Departure from Design Standards Clinton Church of Christ

DDS-682

SUBJECT: Departure from Design Standards DDS-682
Clinton Church of Christ

FIGURE 1.
EXISTING CONDITIONS

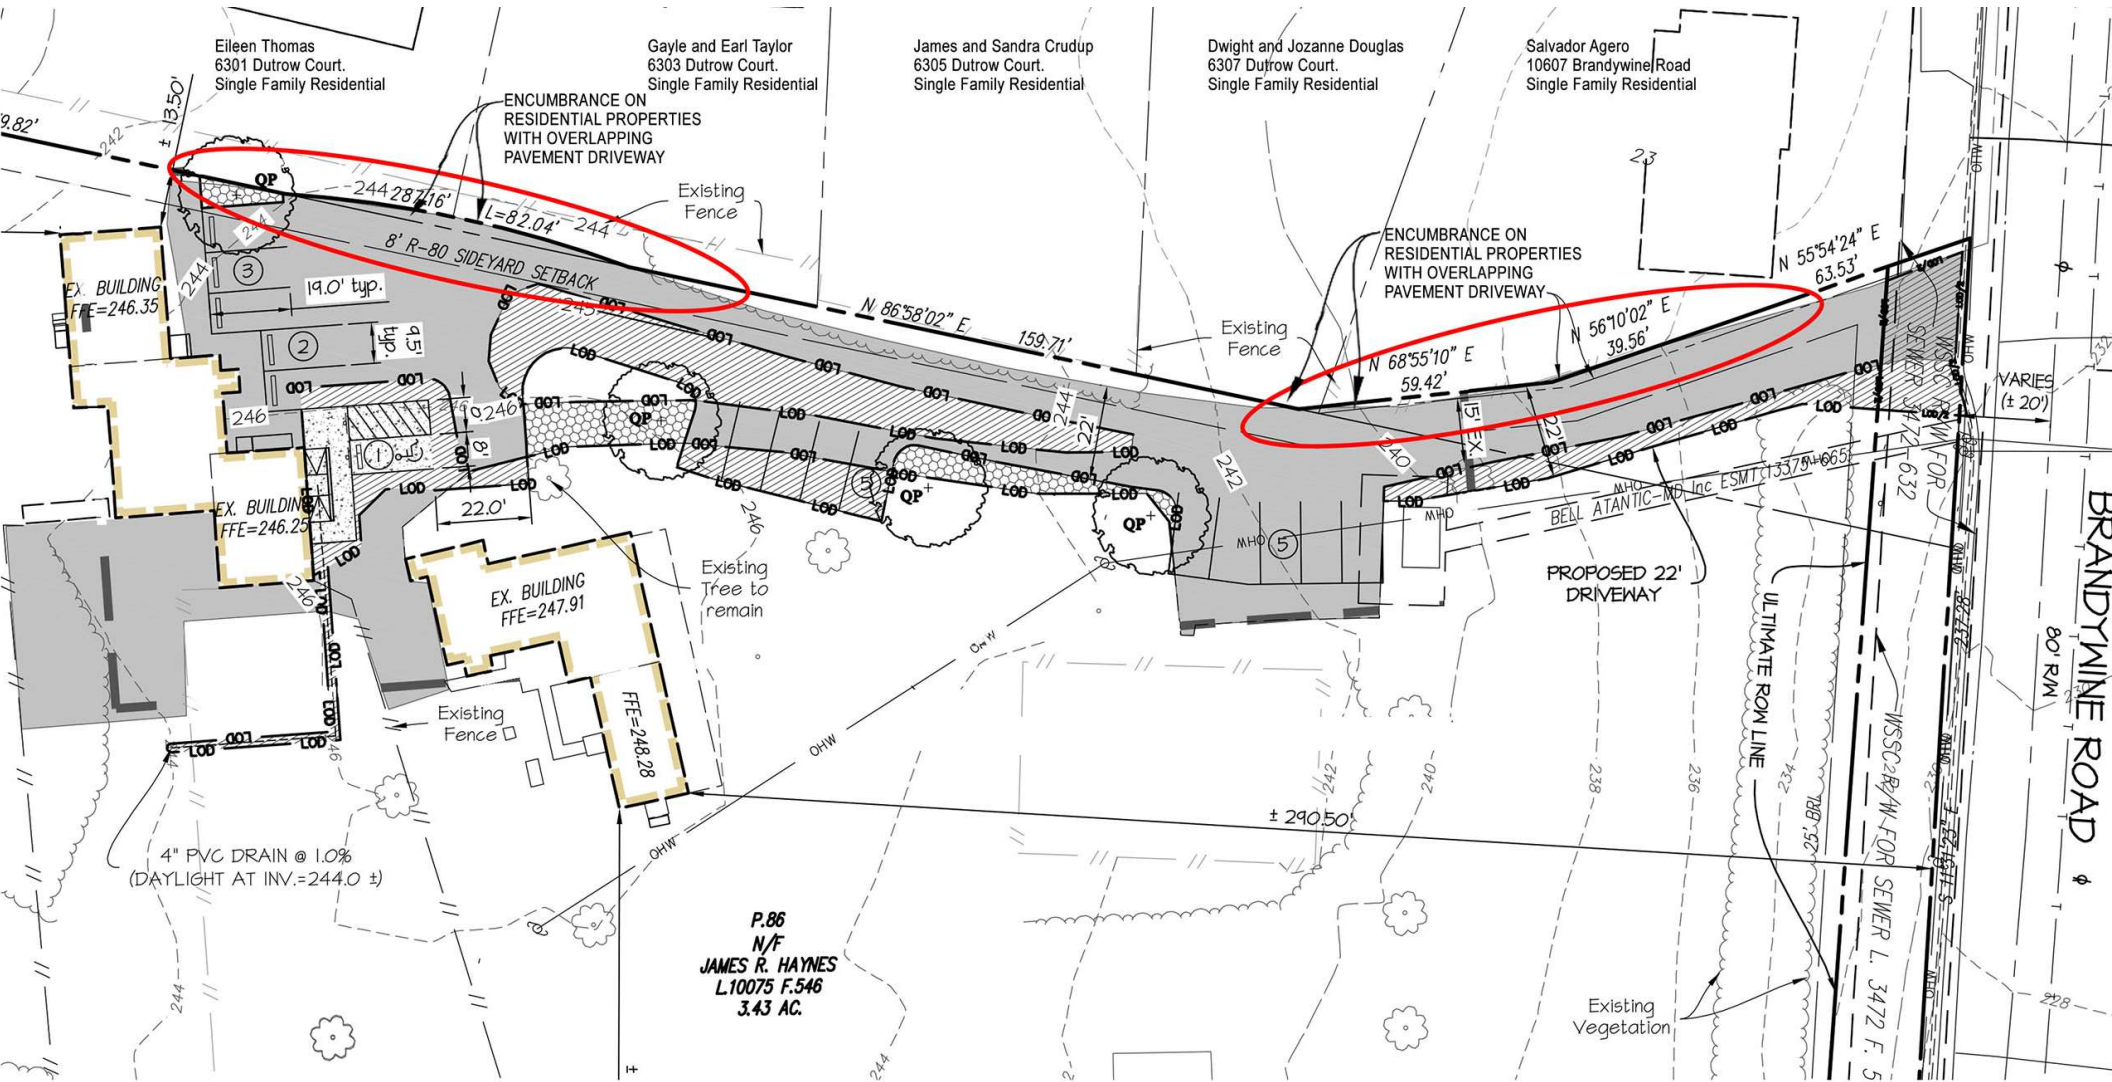
These photos show the close in proximity the rear yard and house of my neighbor's tan home located at 6301 Dutrow Court is to The Church's blue building in the Rear of their property.

These photos also show how close the asphalt driveway and parking spaces are to the residential neighborhoods making them vulnerable to many negative impacts if the 40ft buffer setback is not in place.

Please also note Eileen Thomas lets her family and friend kids play in her back yard regularly, reducing the setback is not safe.

FIGURE 5.

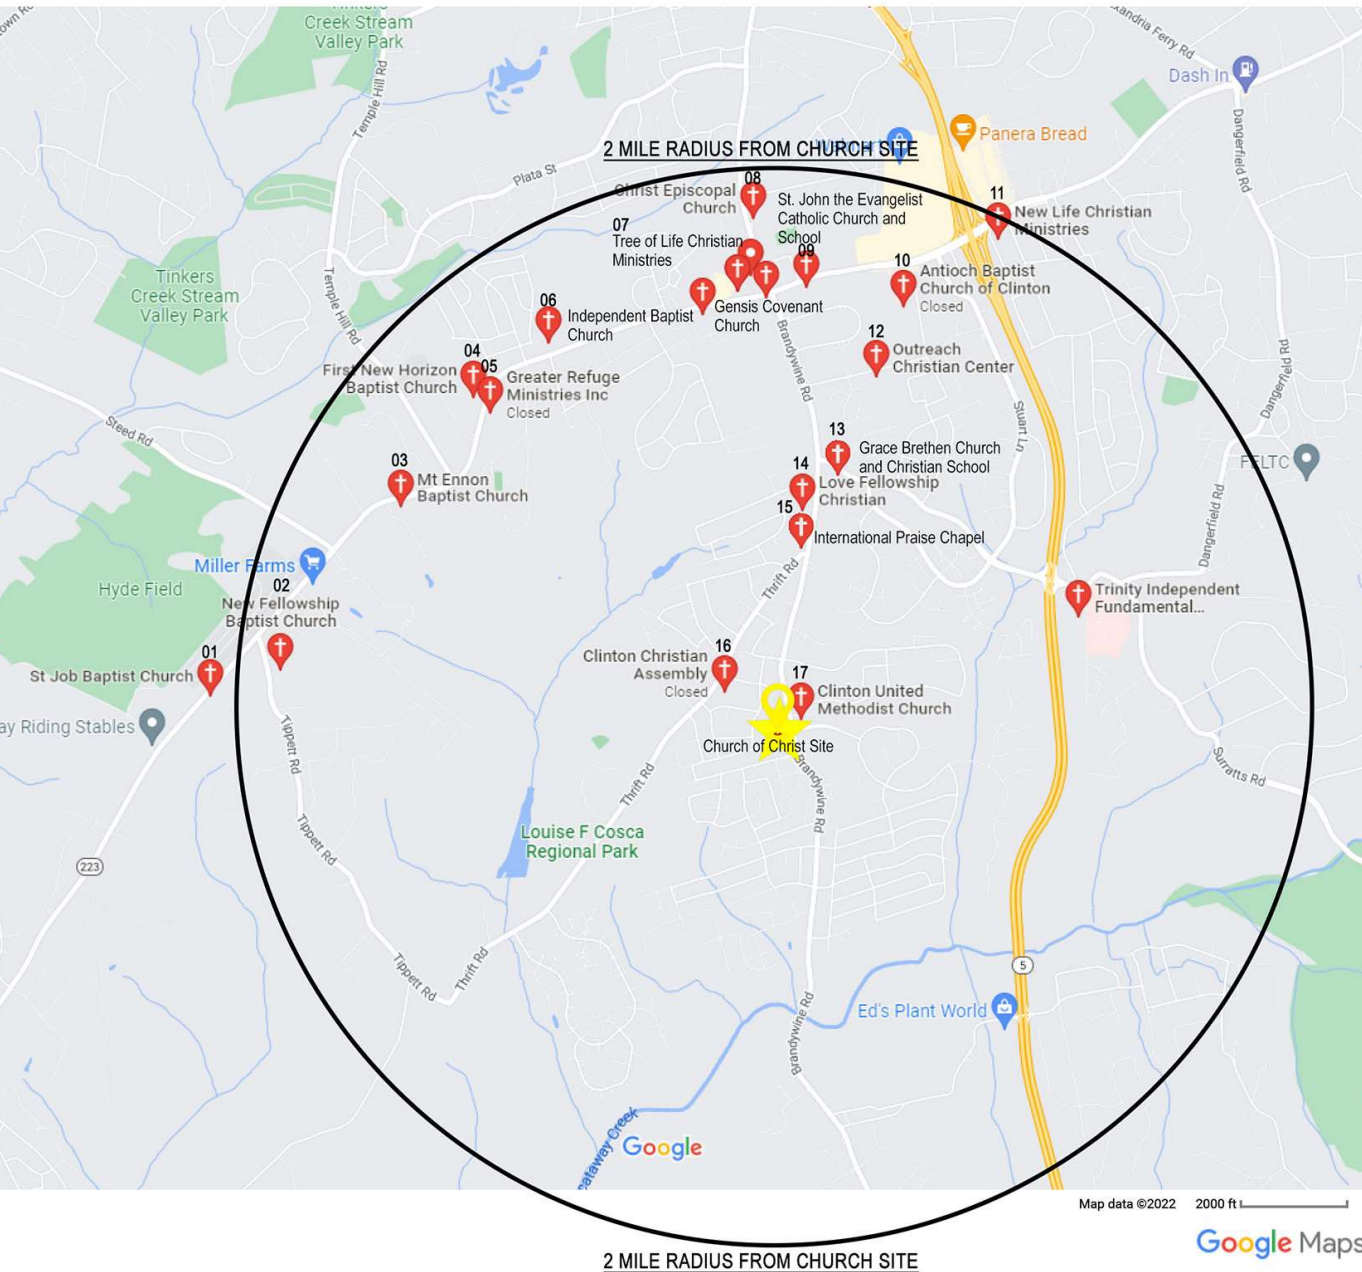
- **Prince Georges County has design standards** for a reason and after reviewing 17 Churches within a 2-mile radius of The Clinton Church of Christ proposed site (figure 5). The conclusion is clear, all have complied with the County's zonal codes and design standards. The nearest Church structure Clinton United Methodist Church is a great example to follow in respecting the community it inhabits with quality design, infrastructure, well-lit parking lots and grounds, and an excellent curb appeal (figure 6). To allow The Clinton Church of Christ the request to depart from the zonal codes will set a precedence that can and may cause many other neighborhoods in Clinton, MD to be negatively impacted by other religious institutions wanting to expand their territories and extending building structures beyond the assigned setbacks simply because they want to. Infringing on the quiet and peace many residential homeowners desire. That is not acceptable.

All these Organizations Complied with the Zonal Regulations and Standards put forth by Prince Georges County and Planning Department.

DDS 682 COMMENTS AND NEIGHBORHOOD ANALYSIS MAP.....Figure 1.

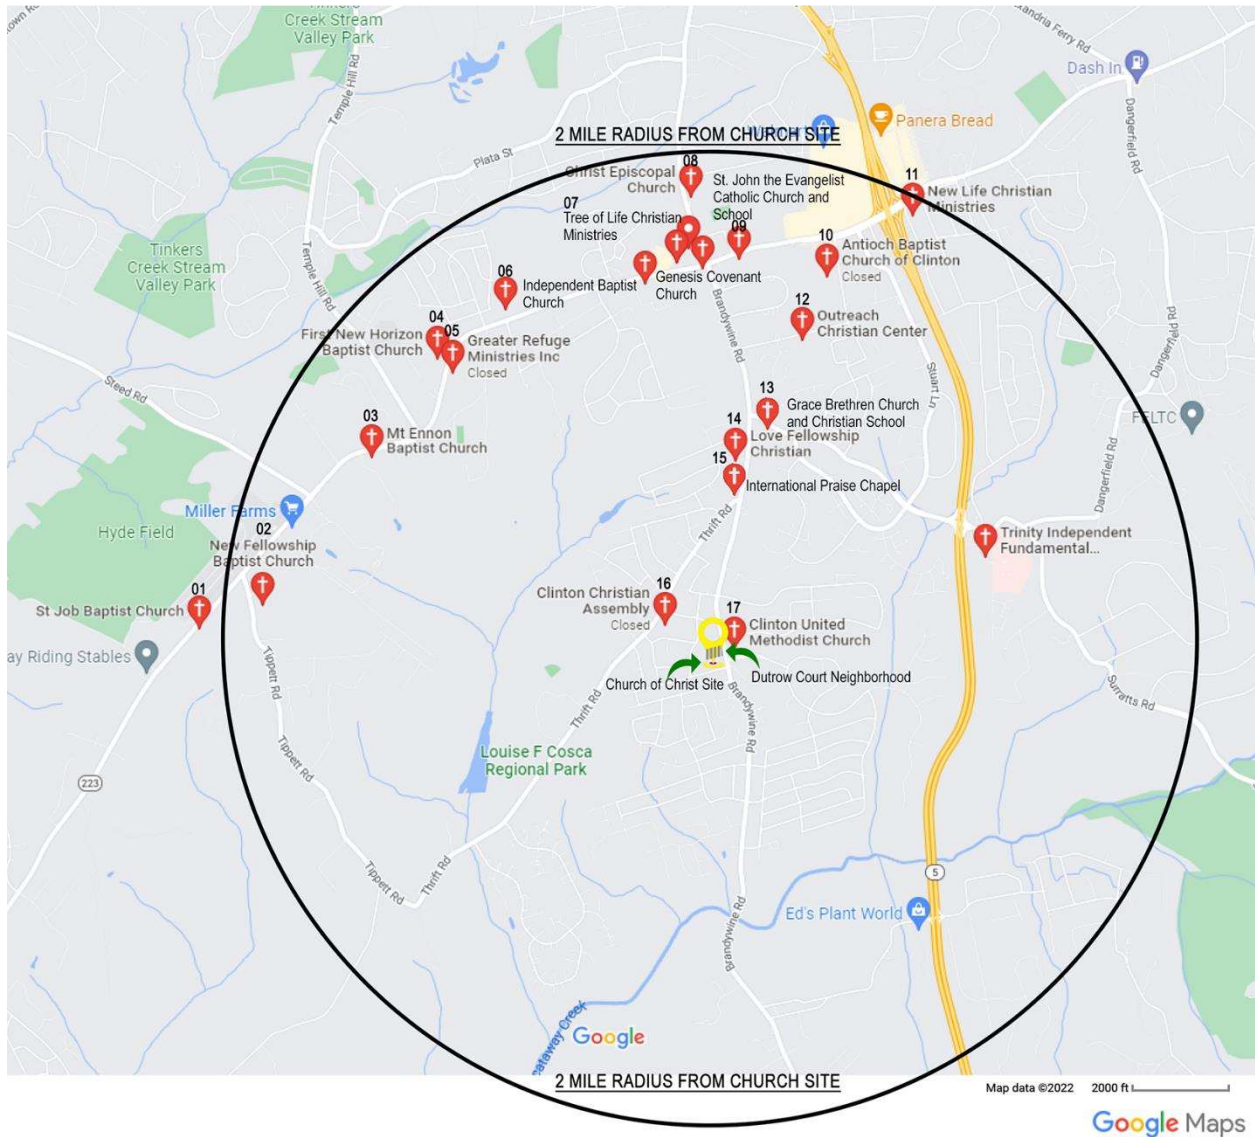
We are against the request for a departure from the design standards and alternative compliance request DDS-682. Our neighborhood already has more than its share of churches. Figure 1 shows that there are more than 17 churches less than 2 miles away from the building that a departure in standards is being requested for the approval of a church. As a matter of fact, there are six churches within walking distance of the proposed site for a “new” church. My immediate neighbors don’t desire to have a church road that butts right up to our backyard fences. The counties currently “on the books” property “set back” standards should be enforced. In addition to the noise church traffic would bring, a church at our back doors would greatly reduce our property value. We have had a quiet, peaceful neighborhood for 36 years and it was not designed to include a church. Additionally, church traffic would enter and exist on to Brandywine Road (Route 381), a heavily traveled state road already overloaded from the addition of several new housing developments. Brandywine Road is also frequently used as a detour for the heavily traveled Route 5 which is parallel to Brandywine Road and less than a half mile away. As such traffic safety is a major concern. More seriously we doubt the church owners will be good neighbors based on past history. For example, suggestions were made to the church more than a year ago for making the possibility of occupancy more plausible to the neighborhood, but they were ignored. The owners of the property in question have not been good stewards of the property thus far. An unsafe condition has existed on the property since it was purchased. There is an unfenced, uncovered deep swimming pool full of filthy water and debris on the property. In addition to being unsafe and a health hazard, the pool serves as a watering hole for wildlife. This serious situation as well as other suggestions for making the property more acceptable has fallen on deaf ears. Obviously we don’t want or need neighbors like this. For the aforementioned reasons, before the neighbors will support adding another church to our immediate area it should meet the same design standards/ building/zoning requirements for any new church that applies for a permit. Approval to departure from current county design standards for this applicant would disrupt a quiet, peaceful neighborhood and cause additional traffic on an already heavily burdened, unsafe road. In conclusion requiring the church to follow all standard building/zoning requirements is a must. We strongly oppose this request and ask the Board to disapprove it. Respectfully,
